Subject: Proposed Hydrostratigraphic Nomenclature – Black Mountain Industrial Complex and Common Areas

Comments on the Proposed Stratigraphy and Hydrogeologic Nomenclature for the BMI Complex and Common Areas

Plate 1 Comments

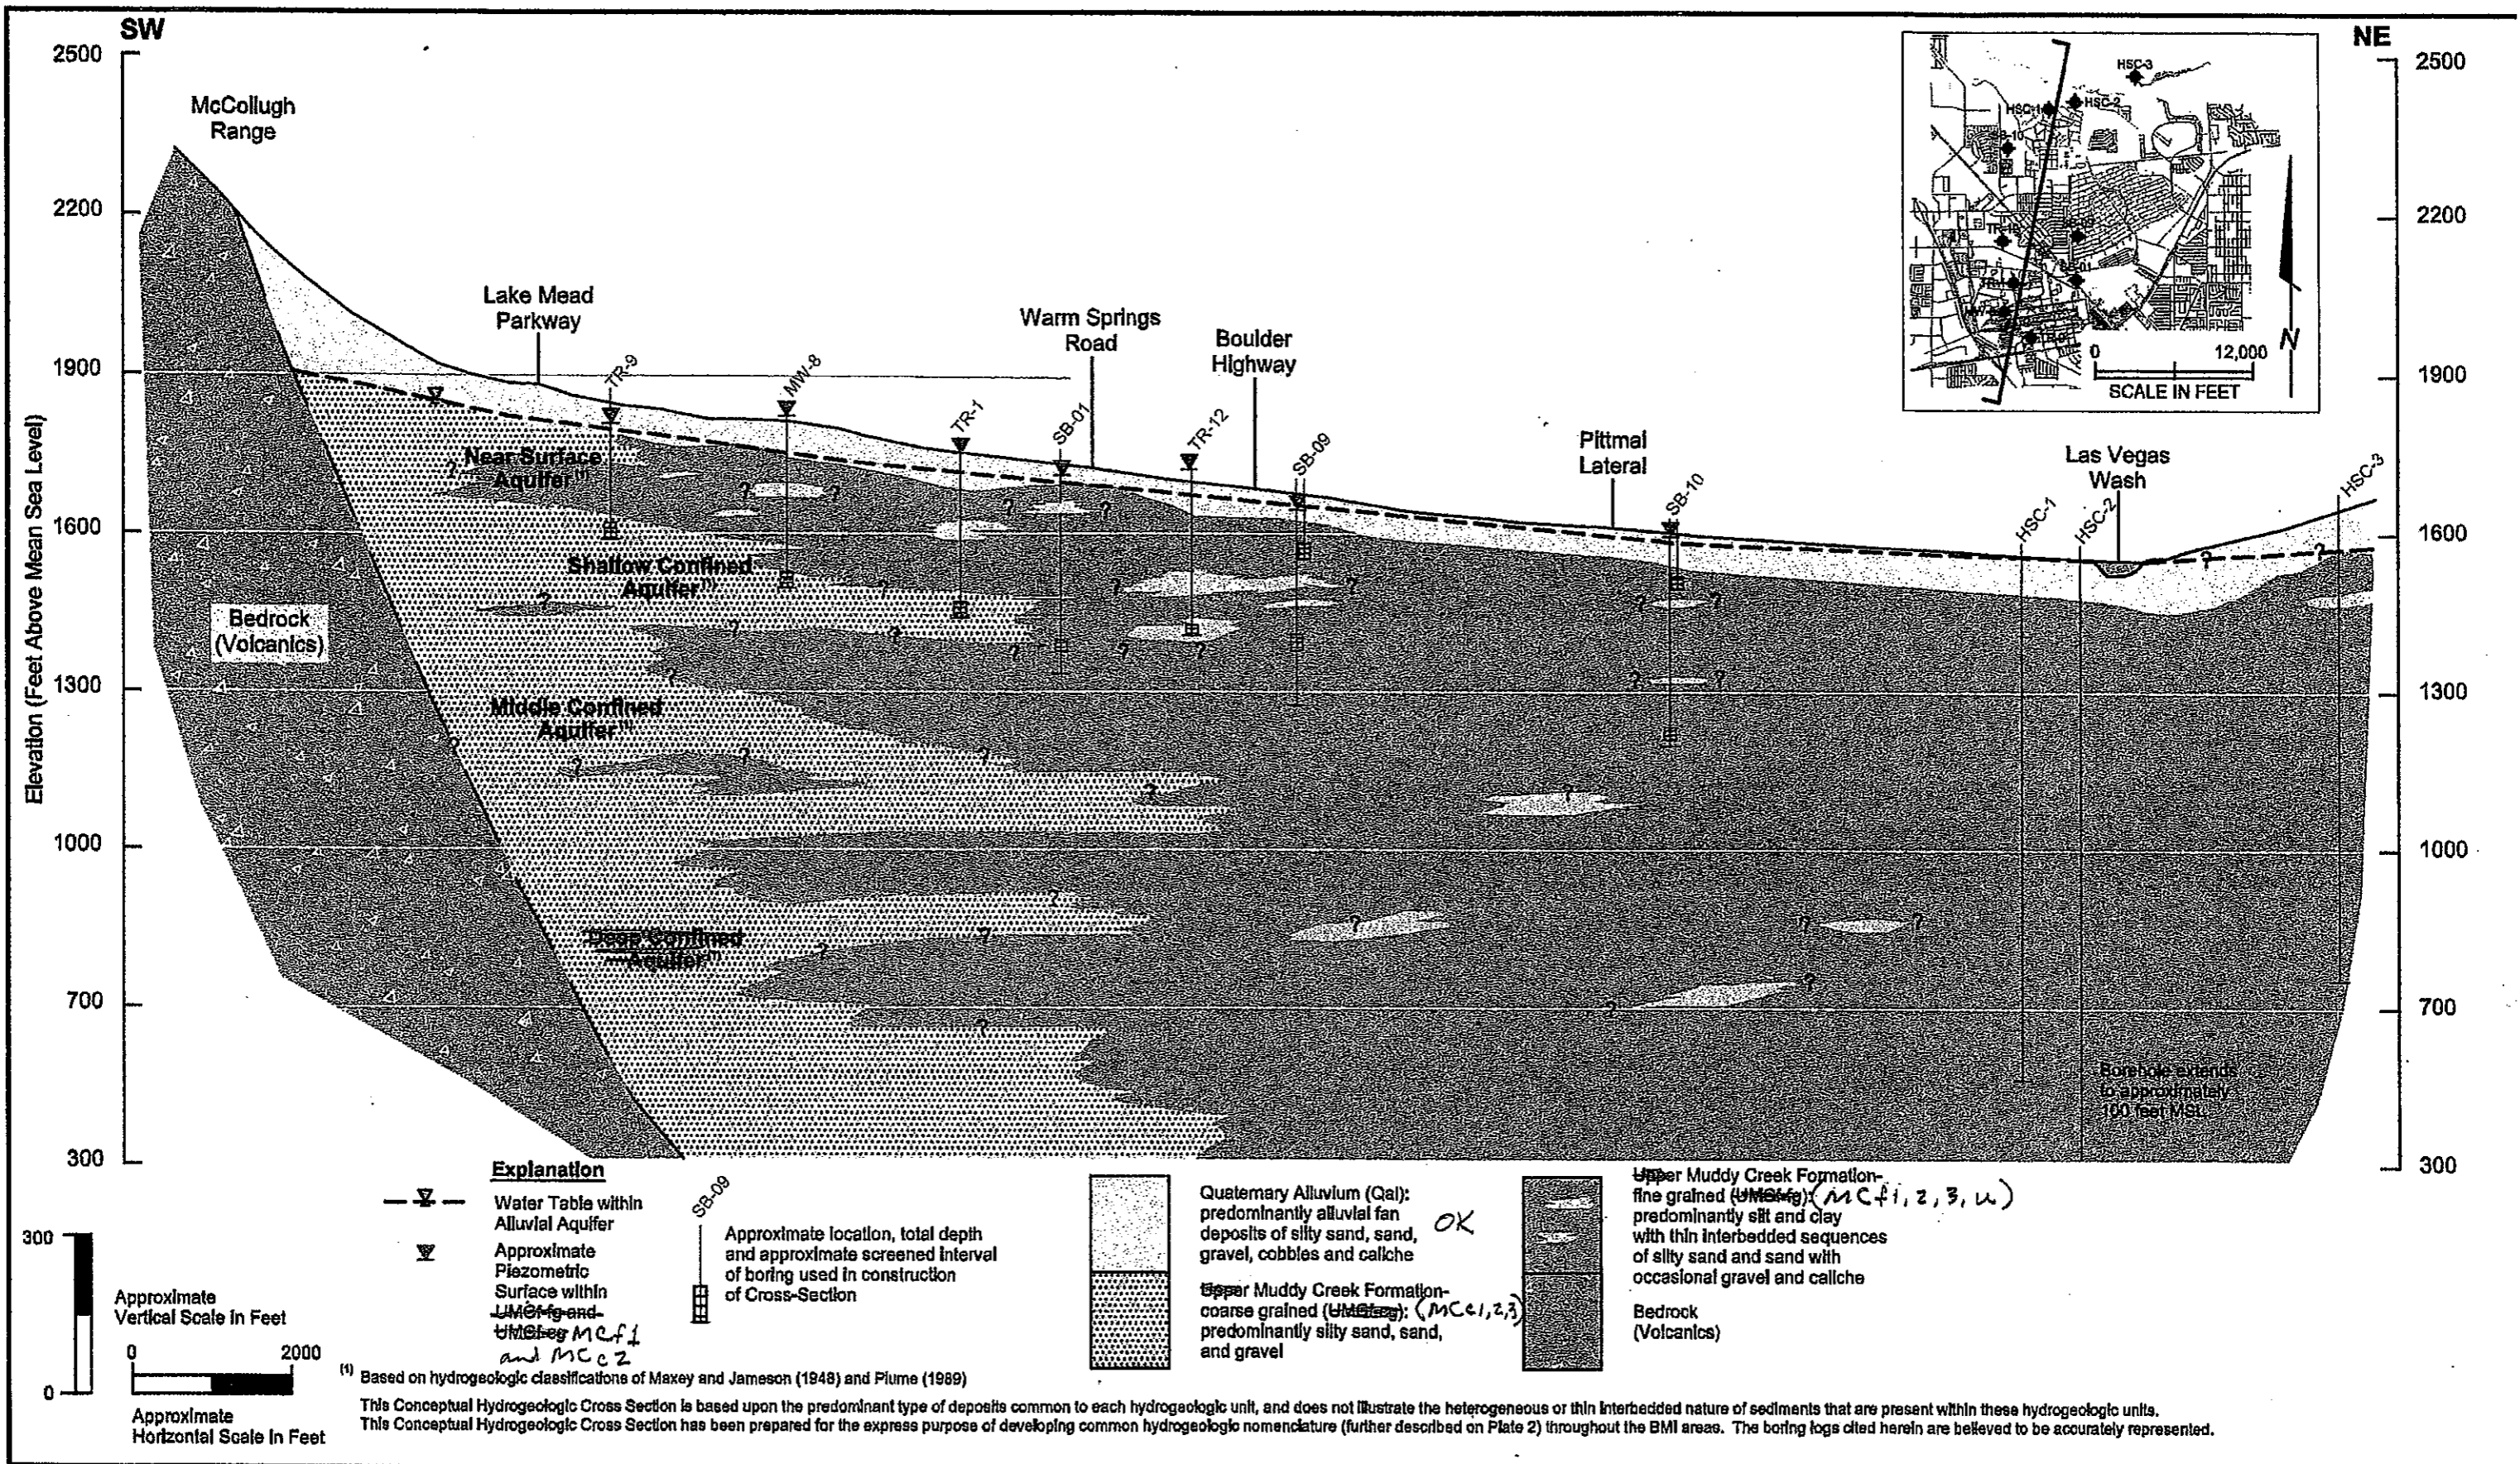
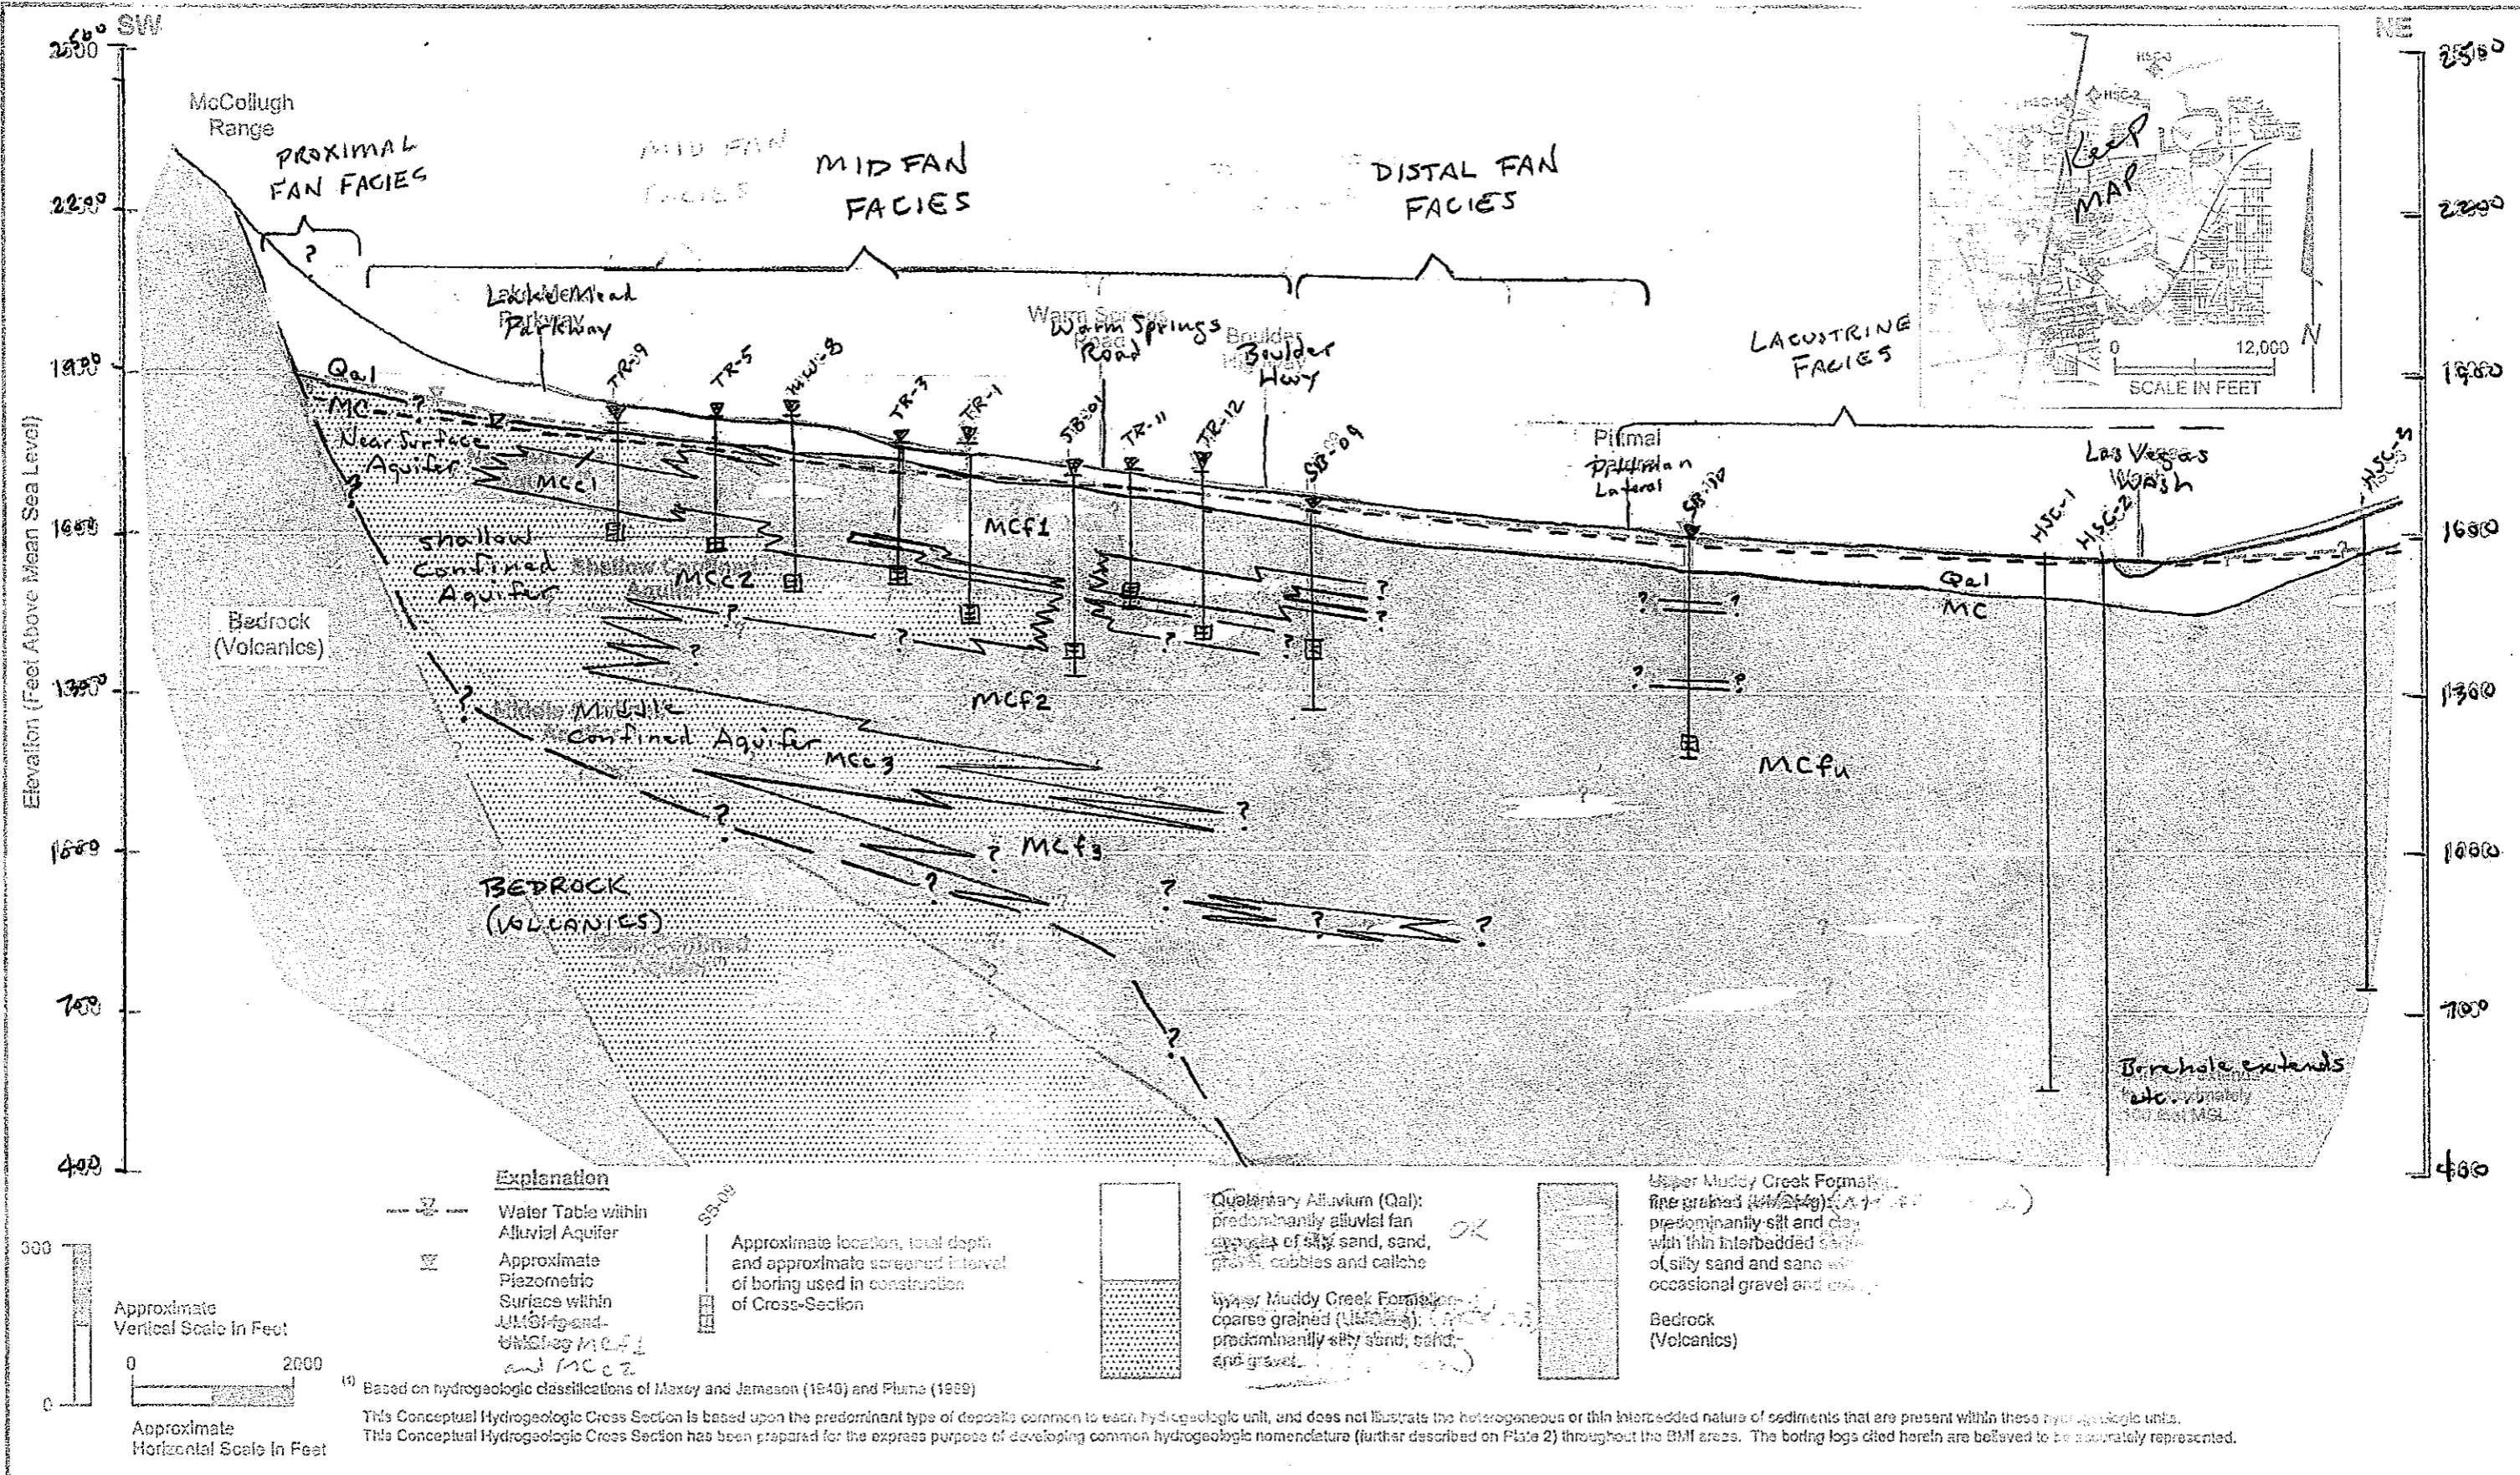
According to Tronox mapping, the shallow MC valley-fill in the area from Lake Mead Parkway north to Las Vegas Wash (LVW) is comprised of the various facies of a large alluvial fan system (proximal fan, mid-fan and distal fan), shown on revised **Plate 1**, depositing into a large lake (lacustrine environment). The source area for this depositional system was the Spring Mountains to the west and the McCullough Range immediately to the south. Structure observed in the MC is probably related to deposition on an alluvial fan or inclined surface and/or tilting related to extensional faulting during the Tertiary Period.

The lacustrine facies, consisting of interbedded silt, sand and clay deposits on the south changing over to massive clay and evaporate deposits on the north, was deposited in a lake environment downgradient of the distal fan facies. In the vicinity of the Pittman Lateral the red and brown silts, clays and fine sands of the distal fan facies are interbedded with green and gray clays and gypsum beds of the lacustrine facies. Farther north, near LVW, massive lacustrine clays and evaporates are found to a depth of at least 1500 feet (**see Plate 1**).

(2) The document author proposes UMCf-cg for both the shallow coarse-grained Muddy Creek (unconfined) and the “deep” coarse-grained Muddy Creek (confined). There needs to be a designation (i.e. number added) to segregate these units, as leaving them the same will cause confusion. Whereas these sediments are derived from the same mountain front alluvial fan system they are stratigraphically and hydrologically different (**see revised Plate 1**).

(3) Whereas the original dip of the beds in the MC alluvial fan system was very gentle, tilting has occurred since deposition and this has been shown on revised **Plate 1**.

(4) The revised **Plate 1** and **Plate 2** shows the preferred naming of the geologic and hydrogeologic units. They are the following:
